Since the release of the Talon BT Shallow Water Anchors in 2018 there have been a few design changes to improve some of the original components. These changes do not represent safety issues, but are an indication of an effort to continuously improve the reliability and performance of the Talon product line. **If the latest/current component part is not already installed, the installation of the new part(s) should be considered an “automatic” update.** Select the corresponding part number in item #1 for the Talon length. This applies to both in-warranty and out-of-warranty units. We will honor warranty claims on all Talon BT Shallow Water Anchors for these updates. Use labor code SB20180801-STG2/PISTON MOD when submitting a warranty claim for three hours of labor. Please review Part 1 - Case V of the [online Talon repair manual/video on the Canto Service Portal](#).

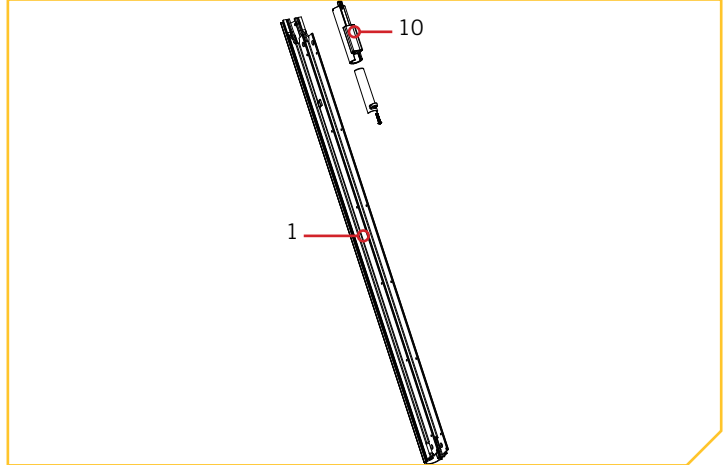
This update is intended to prevent sand or other debris from getting stuck in and around the Spike Piston, causing the Talon to bind. It will require changing the Second Stage Extrusion and spike piston. The two slots in the new Second Stage, along with the fluted spike piston will allow water to flow through and flush out sand and other small debris.

Item	Part #	Description	Qty.
1	2378056	EXTRS,2ND STG MCH,15'BT	1
	2378057	EXTRS,2ND STG MCH,8'BT	1
	2378058	EXTRS,2ND STG MCH,10'BT	1
	2378059	EXTRS,2ND STG MCH,12'BT	1
	X	RIVET-POP, 1/8", 316 SS	12
	X	SHIELD-DEBRIS, 2ND STAGE	1
	X	LATCH, SECOND STAGE	1
	X	SPRING, .360" X .50"	1
	X	PIN, KNURLED, 1/8"	1
	X	DEBRIS-CHANNEL	1
	X	INSULATOR, STOP PIN	1
	X	PIN-KNURLED, 3/16 X 1.400", SS	1
10	X	PISTON ASSEMBLY, TALON 3	1
